RealSense™ Product Family D500 Series

Specification Update

Revision 001

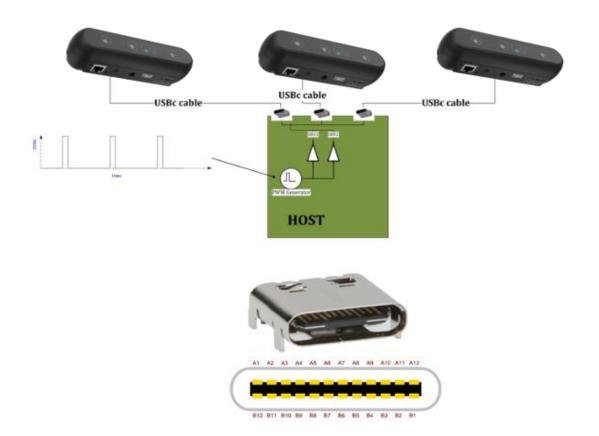
RSDEV-3188	~0.5pixel UV movement to the right for both X and Y axis
Problem:	The calibration conventions in D555 differs from D4xx. In D4xx devices the origin of the pixel is the upper left corner, while in D555 it is the center of the pixel.
Implication:	Texture map misalignment by 0.5 pixel horizontally and vertically in registered depth and texture PointCloud scenarios
Workaround:	None. Users can use external tools/libraries for Texture Mapping
Status:	Refer the Summary Tables of Changes
